Intel[®] Pentium[®] III Xeon[™] Processor Specification Update

Release Date: June 2000

Order Number: 244460-016

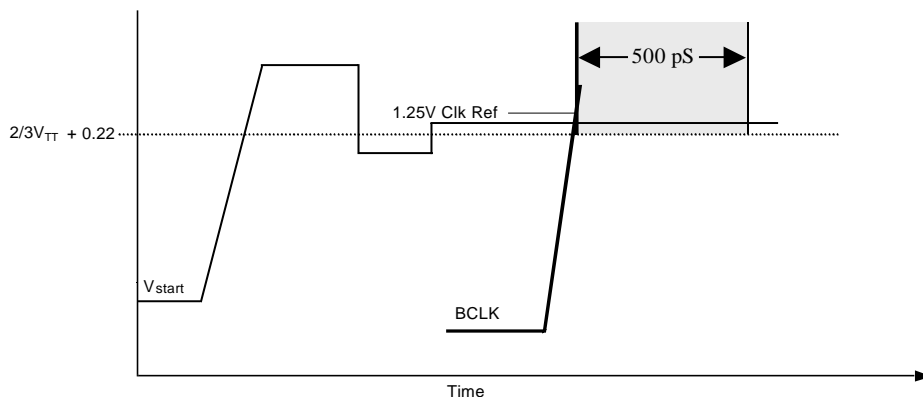
Software using unsynchronized XMC to modify the instruction byte stream of a processor can see unexpected instruction execution from the processor that is executing the modified code.

Workaround: In order to avoid this erratum, programmers should use the XMC synchronization algorithm as detailed in the *Intel Architecture Software Developer's Manual Volume 3: System Programming Guide*, Section 7.1.3.

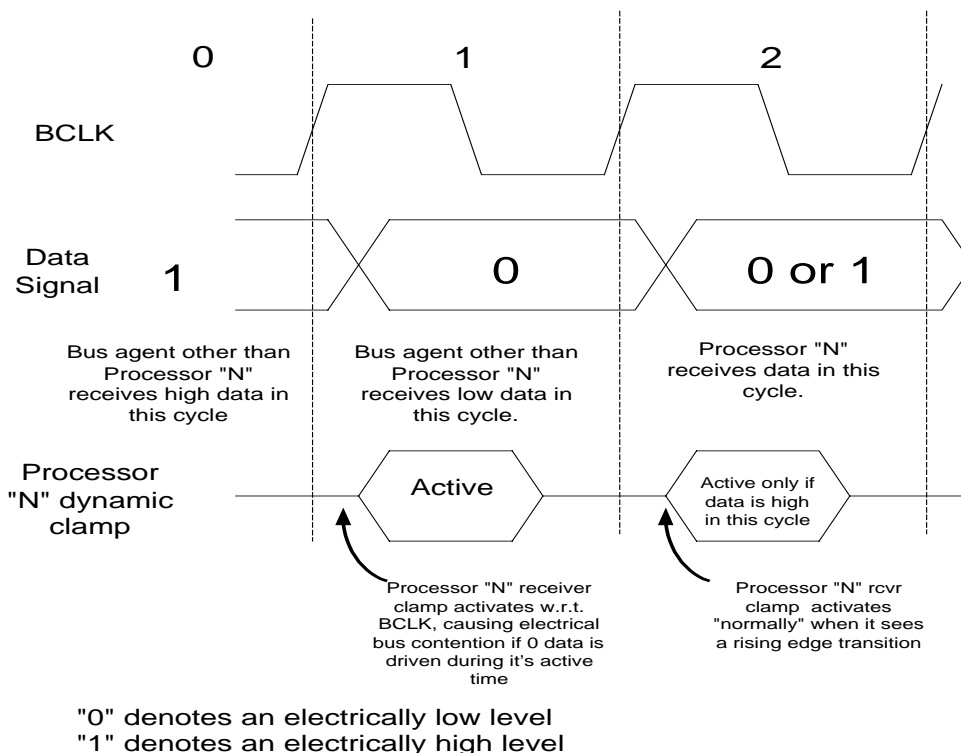
Workaround: The AGTL+ V_{REF} (input voltage reference) level will be raised from 1.0V to 1.1V (assuming a V_{TT} of 1.5V) on the processor cartridge substrate. This allows the dynamic clamp to activate at a trigger level approximately 100 mV higher than with the previous 1.0V V_{REF} setting. Due to the dependence upon system bus design, bus layout may be evaluated to determine the need for improvements in falling edge ringback levels. This may involve one or several of the following baseboard modifications:

1. Change termination resistor value to reduce multi-bit noise and/or improve V_{IL} noise margin.
2. Reduce multi-bit noise by improving ground return paths (additional high-frequency decoupling, improved AC plane referencing, etc.).
3. Raising or lowering the V_{TT} level (within the AC & DC tolerances specified in the processor EMTS) to improve V_{IL} noise margin and/or reduce the multi-bit noise due to dl/dt transients.

Stress tests using various data patterns and transactions should be run to identify the worst-case multi-bit noise conditions for this erratum.
